**BROWNS FERRY NUCLEAR PLANT (BFN) - UNITS 1, 2, AND 3 -
TECHNICAL SPECIFICATIONS (TS) CHANGES TS-431 AND TS-418 -
EXTENDED POWER UPRATE (EPU) - RESPONSE TO ROUND 7 REQUESTS
FOR ADDITIONAL INFORMATION (TAC NOS. MC3812, MC3743, AND
MC3744)**

**TECHNICAL SPECIFICATIONS (TS) CHANGES TS-431 AND TS-418 -
EXTENDED POWER UPRATE (EPU) - RESPONSE TO ROUND 7 REQUESTS FOR
ADDITIONAL INFORMATION (TAC NOS. MC3812, MC3743, AND MC3744)**

Figure EEMB.39-1
Typical Steam Separator

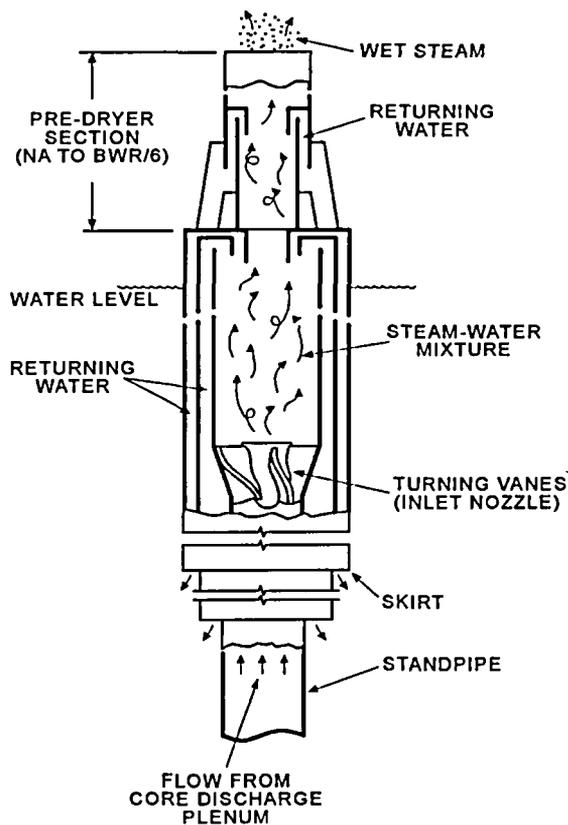
in a separate analysis. Provide a summary of the quantitative evaluation for the effects of flow induced vibration on steam separators for the proposed EAU condition at Units 2 and 3.

The magnitudes of the turbulence excitation change with the square of the separator velocity. Because there are no distinct peaks or valleys in the turbulence excitation spectrum, the separator, shroud head, and shroud/top guide assembly vibrate at the structural system natural frequencies. Because the structural natural frequencies are not changed by higher steam flow rates, the vibration frequency is the same irrespective of the power level. The higher EPU steam flow rate only results in higher vibration amplitudes at the structural natural frequencies.

Also, there are no known structural problems related to temperature or flow effects in steam separators. Thus, EPU is not expected to have any detrimental effect on the structural integrity and functionality of the steam separators.

Figure EEMB.C.15-1

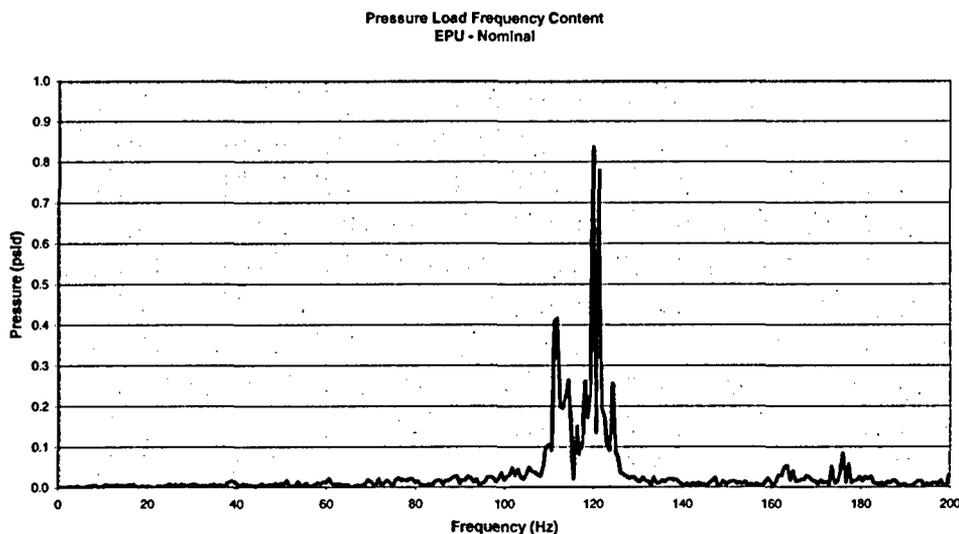
Discuss the source of the pressure peak near 175 Hz in Figure 6-1.

Review of the BFN main steam line geometries does not identify any MSL components that would contribute this frequency content. This review suggests that the frequency content near 175 Hz is not a deep cavity resonance similar to the ~120 Hz frequency content. Also, the 175 Hz content is similar to the lower frequency steam dome acoustic mode frequency content in two regards: 1) amplitude of resonance is much lower than S/RV resonance and closer to amplitude of lower frequency steam dome acoustic mode resonances, and 2) the frequency content is more broadband than an S/RV resonance and is more similar to the appearance of the steam dome acoustic resonances. Figure EEMB.C.15-1 below contains the same data as presented in Figure 6-1 of GE-NE-0000-0053-7413-R2-P; however, the axes are presented in linear scale rather than log scale. This more clearly shows that the amplitude of the 175 Hz frequency content is substantially lower than the S/RV resonance. The plots contained in Appendix D of GENE-0000-0052-3661-01 show the more broadband nature of this frequency content as measured in the SMT. GE testing has shown that the majority of the fluctuating load applied to the steam dryer is contributed by steam dome acoustic modes excited by various aero-acoustic sources in the BWR main steam system. The steam dome acoustic modes with pressure anti-nodes adjacent to the main steam nozzles are considered to be more susceptible to excitation than modes without anti-nodes close to the main steam nozzles because the majority of the main steam system sources exist in the main steam lines. It is considered probable that this load component is contributed by a steam dome acoustic mode as described above.
